Appendix 1: CPMP 2019 (17/00290/FULL): Updated response to latest public consultation following revisions received by GBC 18 Nov 2019

OVERVIEW

The purpose of this report is to provide details and evidence to support the comments and remaining objections the Residents Association has to the latest revisions to the CPMP proposals submitted by the applicant mid-November 2019 (17/00290/FULL).

Some photos of visitor cycles 28 Aug 2019...

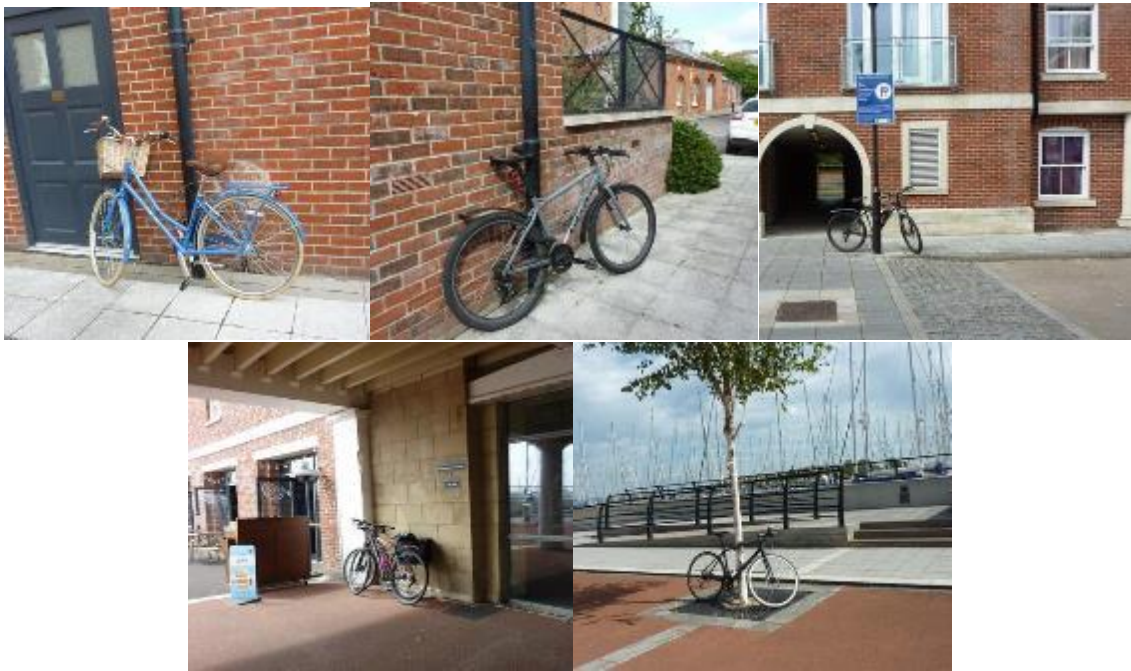
We understand that provision for short-stay visitor cycle parking should have been included in the approvals for each Phase. However, since the only "cycle storage" provided for Phases B, C, E and H is in locked cycle sheds, only accessible by residents and commercial tenants with the correct code, these are clearly not available for short-stay use by visitors. If short-stay visitor cycle storage was supposed to have been provided for these Phases under previous approvals, this has clearly not been implemented. The net effect is a clear lack of provision for visitor cycles across Royal Clarence Yard, which results in visitor cycles being chained to lamp-posts, railings and other structures, in some cases blocking the pedestrian walk-ways and presenting an untidy/disorganised appearance which is out of keeping with the settings of the Listed Buildings and the RCY Conservation Area.

The applicant has made no new proposals for the provision of adequate visitor cycle parking in convenient locations. We therefore continue to **object** on this issue. It is essential that the applicant identify suitable areas for and implements visitor/short-stay cycle parking, with clear signage, which can be easily located by visitors.
